Limerick Generating Station, Units 1 and 2
Facility Operating License Nos. NPF-39 and NPF-85
NRC Docket Nos. 50-352 and 50-353

Subject: Additional Information Supporting Request for License Amendment Regarding Measurement Uncertainty Recapture Power Uprate

RESPONSE TO REQUEST FOR ADDITIONAL INFORMATION

Estimated capability curves
 Dwg. 369HA861 (rev 2)

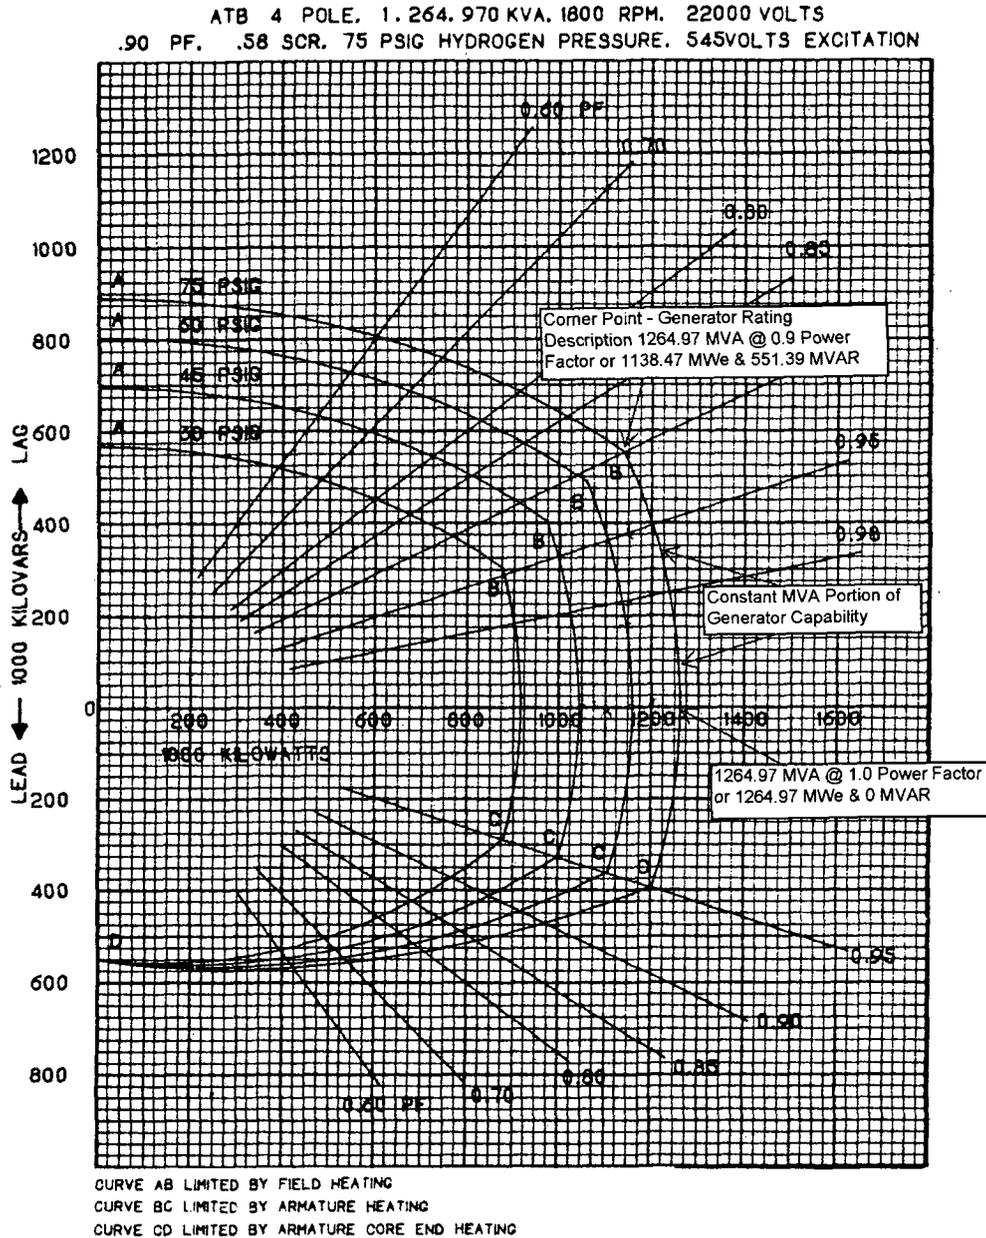
The LAR, Attachment 6, Table 6-2, shows the main generators maximum nominal rating for the uprated condition as 1138.47 MWe [Megawatts electric] and 551.39 MVar [Megavolt-amp-reactive]. The main generators maximum nominal rating of 1138.47 MWe is significantly lower than the expected full load generator output value of 1240 MWe for winter following MUR power uprate, as specified in the LAR, Attachment 12, Appendix B page 2 of 5. Please explain how the main generators worst case (winter) expected MWe output can exceed the maximum nominal MWe rating.

LAR Table 6-2 shows the generator nominal rating of 1264.97 MVA at 0.9 power factor and 75 psig hydrogen pressure. The 1264.97 MVA at 0.9 power factor can also be stated as 1138.47 MWe and 551.39 MVAR. This rating refers to a single point on the generator capability curve where the stator and armature capacity are the same at a lagging power factor. This point is also referred to as a corner point. The corner point is shown on the attached generator capability curve for Limerick. For values of power factors between 0.9 lagging (Point B on the curve) and 0.95 leading (Point C on the curve) the generator capability curve is a constant MVA curve. The generator can operate on or below this constant MVA curve. For Limerick the constant MVA curve is 1264.97 MVA. As a result, at 1.0 power factor the generator can produce 1264.97 MWe and 0 MVAR. At all the points on the constant MVA portion of the curve the vector sum of the MWe and MVAR are equal to 1264.97 MVA. The generator can operate on or below the capability curve but not above it. Therefore, the winter loading of 1240 MWe is associated with an MVAR limit of no more than 250.1 MVAR or a total of 1264.97 MVA. The MWE and MVAR loading are controlled at or below this curve as requested by the transmission system operator.
